SERVICE BULLETIN 111

REDUCTION OF FORCE REQUIRED TO OPERATE PARACHUTE TYPE TOP VENTS

SERVICE BULLETIN 111

Revision A

DRAWING AMENDMENT NO. 145 SH. 1 OF 1 DATE 3-25-80 1K

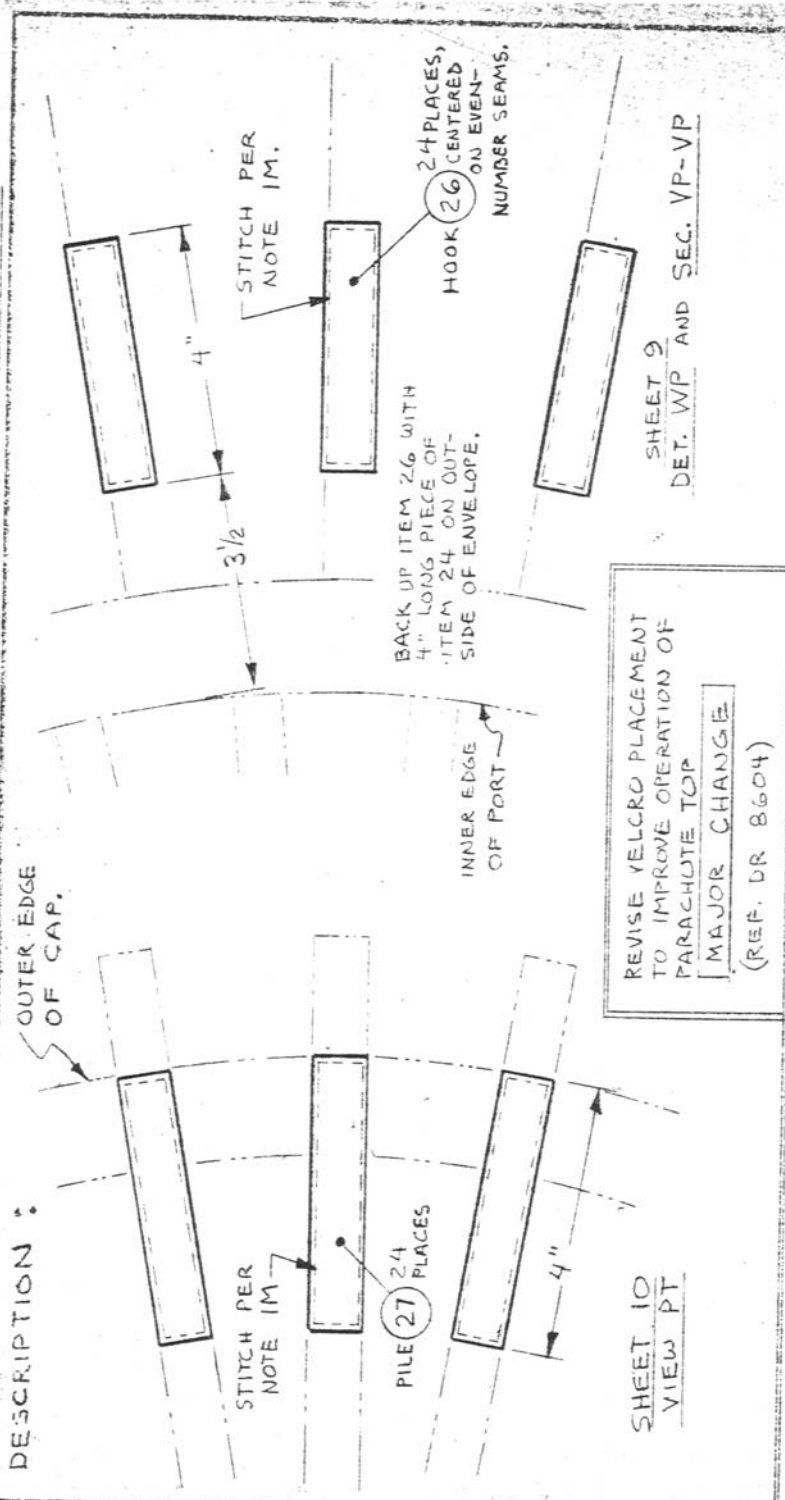
Recently manufactured balloons having parachute tops with 4" long vertical positioning tabs are in compliance with FAR 31.57B and need not be modified. These balloons have a full 4" of hook and pile and should be left as such with NO SHAVING OF EITHER HOOK OR PILE NECESSARY OR INTENDED. This includes all balloons manufactured and tested at Raven Industries on or after March 13, 1980.

THIS DESIGN IS ALSO APPROVED AS A FIELD MODIFICATION TO BALLOONS MANUFACTURED PRIOR TO MARCH 13, 1980. The modification procedure is as follows:

Remove the pieces of Velcro hook located directly below the deflation port and relocate by sewing the 4 inch long 1 inch wide pieces of Velcro hook in position such that the 4 inch pieces of Velcro hook are located vertically on the even numbered half gore seams with one end located 3½ inches and the other end located 7½ inches from the edge of the deflation port. This positioning of the pieces of Velcro hook is oriented 90° from that of the original design.

Remove the pieces of Velcro pile located on the parachute top and relocate by sewing the 4 inch long 1 inch wide pieces of Velcro pile in position such that one end of the 4 inch pieces of Velcro pile is located even with the edge of the parachute top and that the other end of the four inch piece of Velcro pile is located four inches from the edge of the deflation cap. Again, this new positioning of the Velcro is oriented 90° from that of the original design.

REVISE VELCRO PLACEMENT TO IMPROVE OPERATION OF PARACHUTE TOP
 MAJOR CHANGE
 (REF. DR 8604)
